Sub: Minutes of the Meeting on reliability of GTO and IGBT based traction converter (SR) auxiliary converter (BUR) and vehicle control unit (VCU) in three phase electric locomotives.

**Minutes of performance review meeting held at ELS/BIA on 19/20-07-2018on
Propulsion equipment of IGBT based 3 Phase locomotives**

Fig: Schematic of BR ramp up/ramp down timings

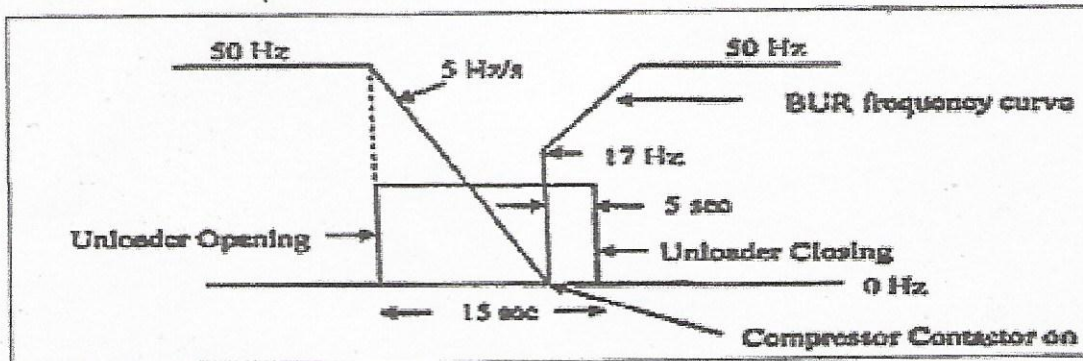
Railways have reported about non-standard timing of ramp up/ramp down in BUR which creates of lot of confusion and issue of generation of unwanted signal. In this

regards all converter manufacturers are advised to implement the ramp up/ramp down time as given below which has been successful implemented in MICAS based loco.
